Subject: Corrective Action Design - Response to Comments
Hamilton Landfill Closure
MassDEP Transmittal Number X252969

**TOWN OF HAMILTON, MASSACHUSETTS
HAMILTON LANDFILL CLOSURE PROJECT**

CORRECTIVE ACTION DESIGN

SUBGRADE PLAN

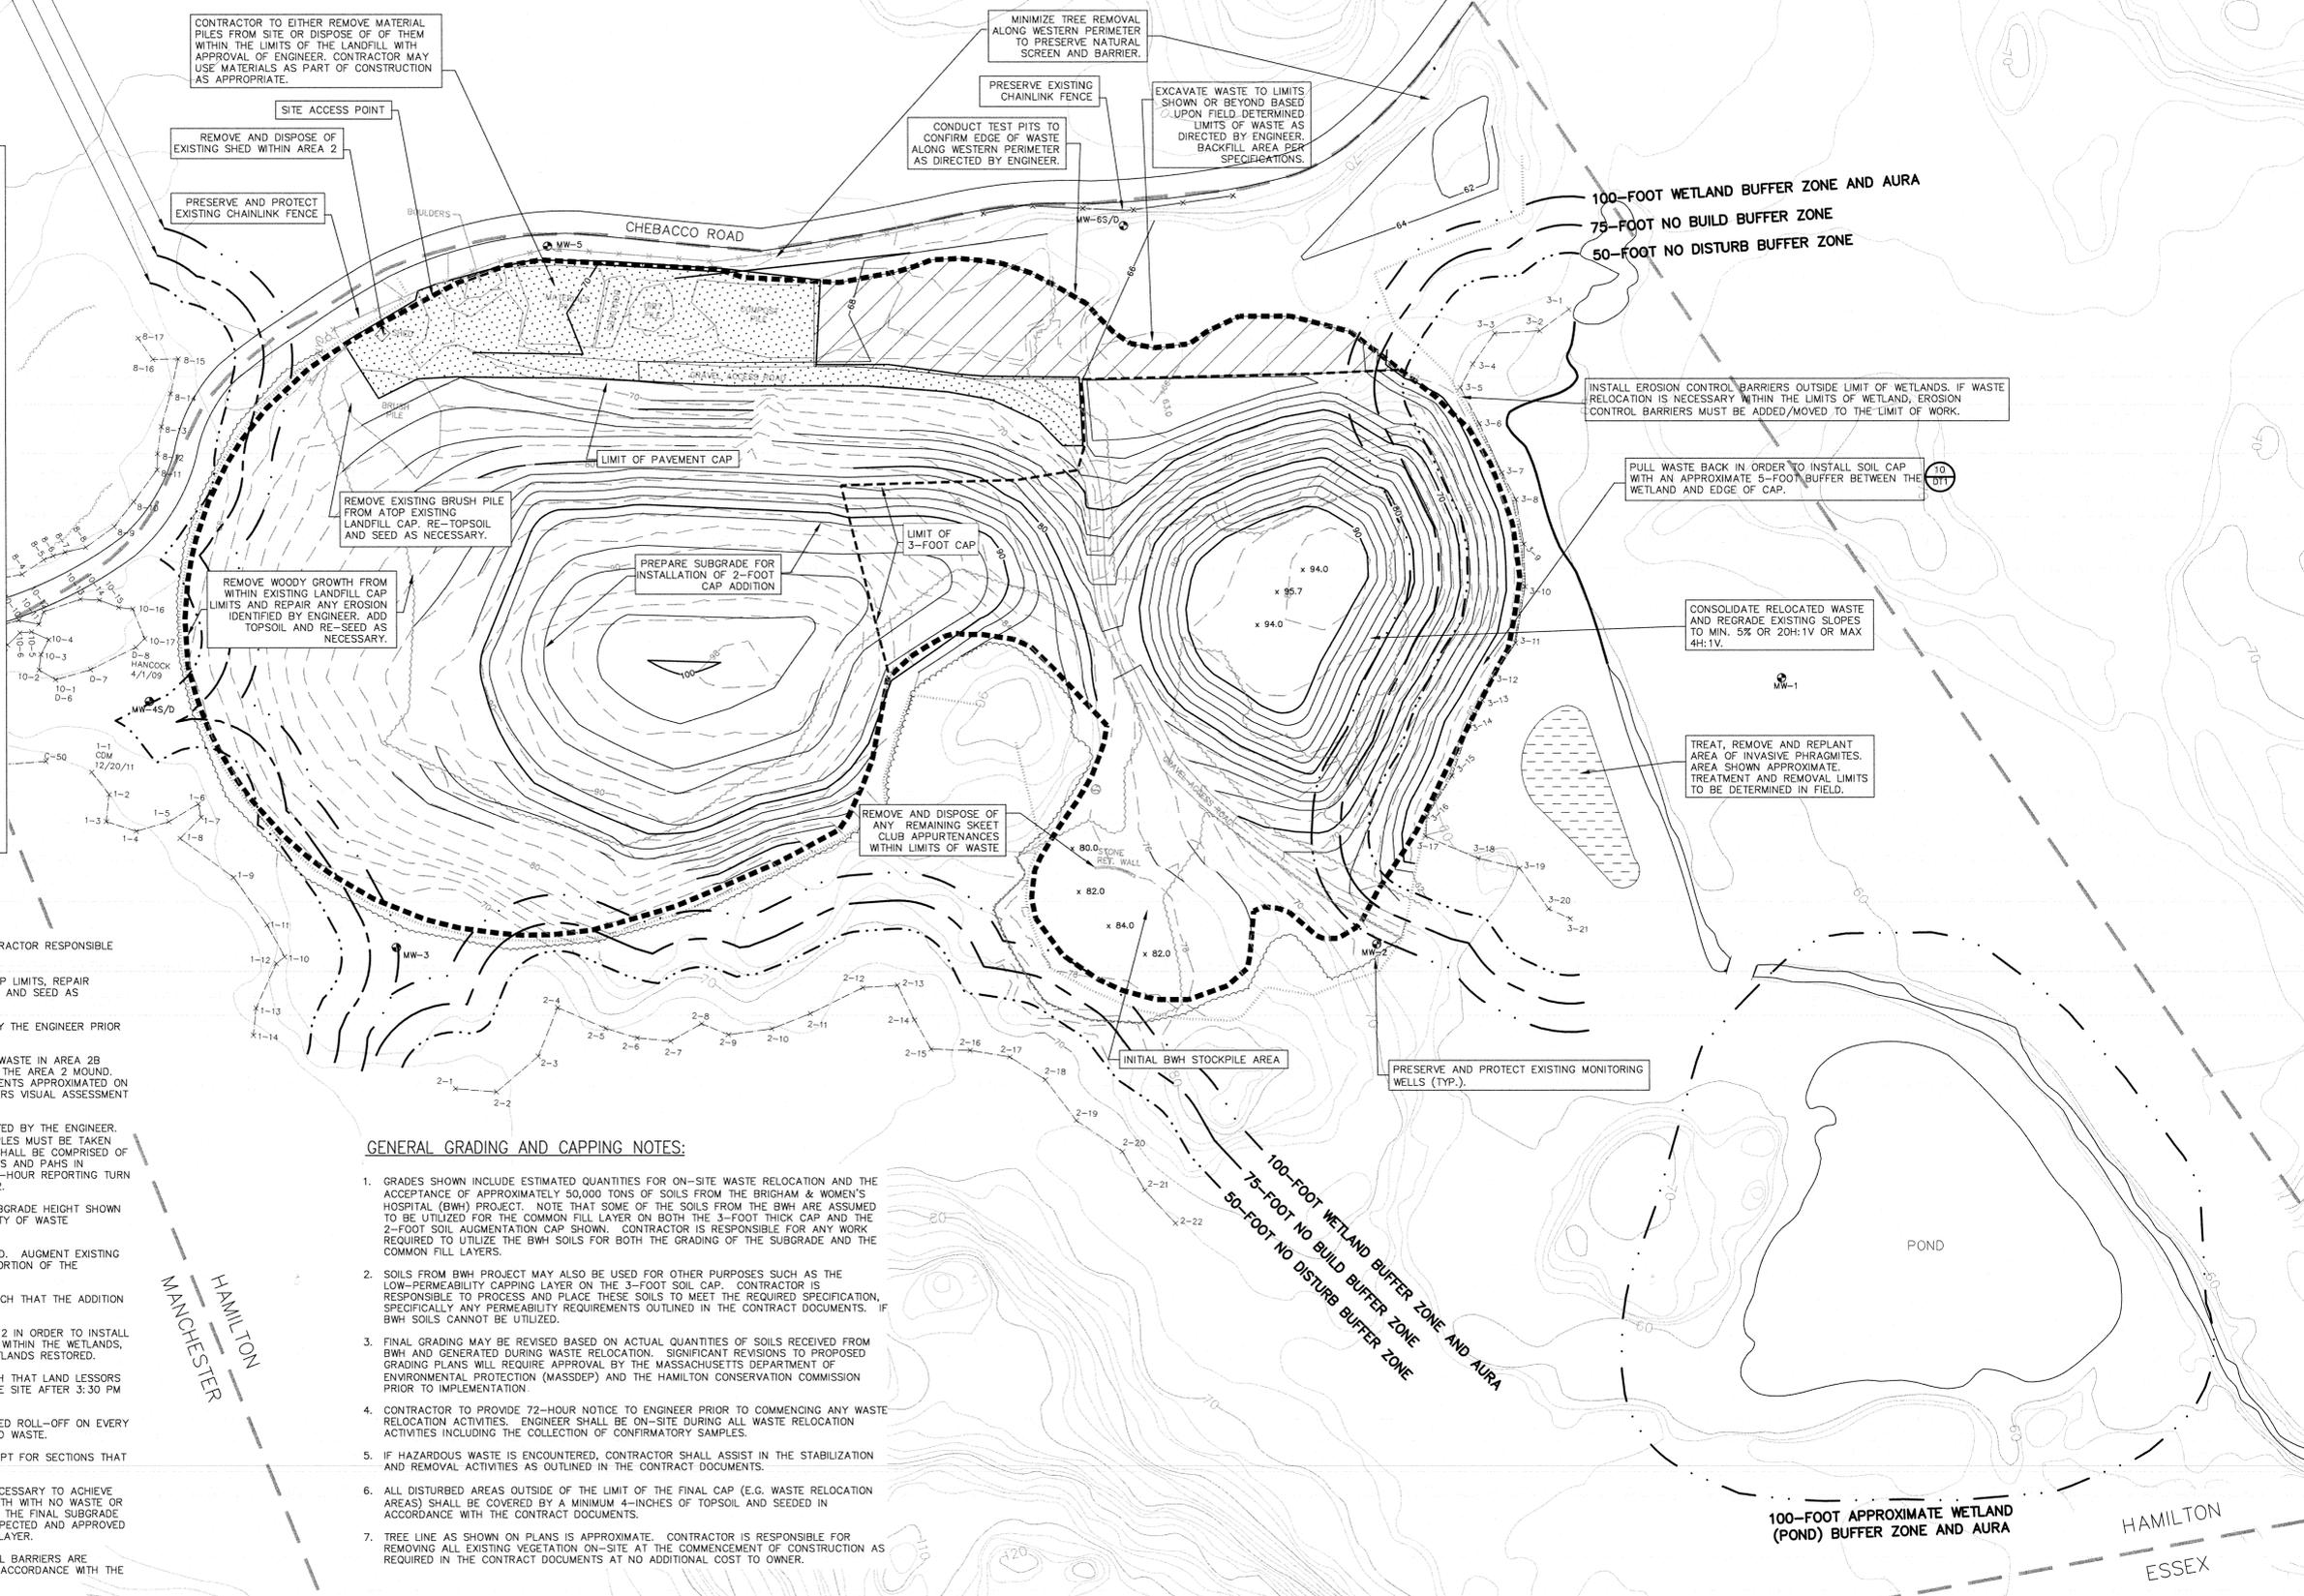
Areas 2 and 2A Material Volumes. The Applicant proposes to relocate waste from portions of Areas 2 and 2A. Based on previous test pits, how much waste is anticipated to be excavated from these areas? On Sheet C-2, Subgrade Plan, how much volume above the existing grades do these grades represent?

Construction Erosion Controls Area 1. The entire surface of Area 1 of the landfill will be cleared and grubbed in preparation to restoring the cap. Therefore, erosion control (haybale and silt fence)

measures around the entire perimeter of Area 1 may be required. Please address this including any measures required by the town of Hamilton Conservation Commission, if applicable.

Conflict Sheet C-2, Subgrade Plan and Sheet D-2. The note on Sheet C-2 states: Pull waste back in order to install soil cap with an approximate 5-foot buffer between the wetland and edge of waste. Detail 10 on Sheet D-2 shows that the 5-foot buffer is between the edge of the soil cap and the wetland. Which is correct

Response: Based upon test pit information, waste extends to approximately an average depth of 5-feet below ground surface (bgs) in both Areas 2 and 2A. The volume of waste anticipated to be excavated from Area 2A is 6,500 cubic yards and from Area 2 is 6,800 cubic yards, including general re-grading of the mound. The volume between the existing grades and proposed subgrade is approximately 14,000 cubic yards, leaving an approximate remaining volume of 700 cubic yards for daily cover volumes and a small increase in relocated waste volumes.

Response: Erosion control barriers were added to the plans submitted to the Hamilton Conservation Commission (HCC) for the Notice of Intent (NOI) Application. The erosion control barriers are also shown on the revised Sheet C-2 as included in Attachment A. The HCC approved the project on October 9, 2013.

Response: The 5-foot buffer is between the edge of the soil cap and the wetland as shown on Detail 10, on Sheet D-2. The note on Sheet C-2 is referring to the revised edge of waste and not the existing edge of waste. The note has been revised to clarify this and reads: "Pull waste back in order to install soil cap with an approximate 5-foot buffer between the wetland and final edge of cap".

GRAVEL ACCESS ROAD AND SOIL CAP TRANSITION
DETAIL 11
NOT TO SCALE

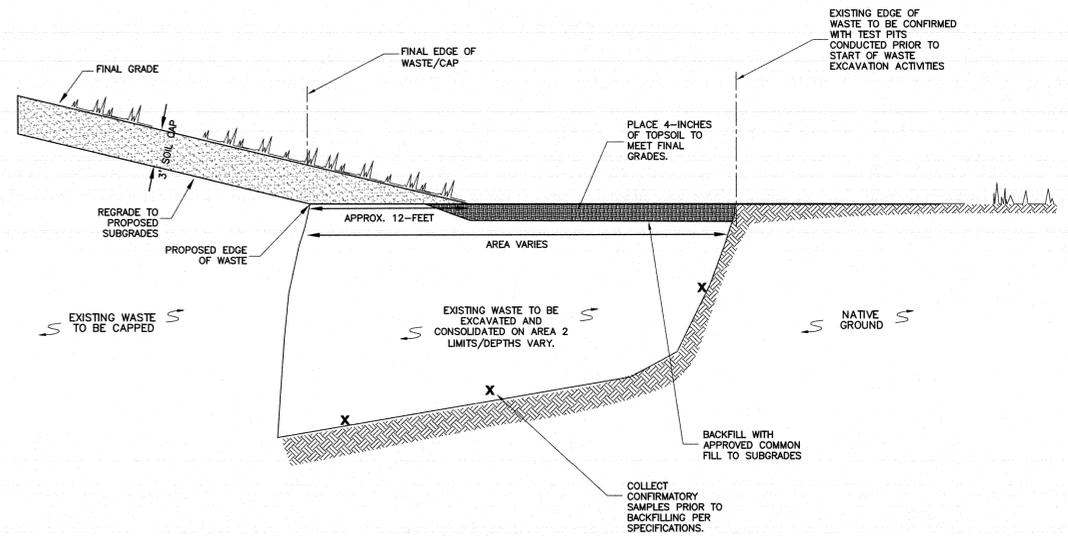
Detail 11 on Sheet D-2 Gravel Access Road and Soil Cap Transition. The collection and transportation of storm water off the landfill cap must be addressed

Response: The revised final grading plan shows a different topographical transition from the soil cap to the gravel access road to incorporate stormwater controls. A grass swale has been designed on the north side of the access road to transmit flow along the transition areas and prevent potential erosion gullies along the edge gravel access road. A detail showing this transition and swale is included on Detail Sheet D-2.
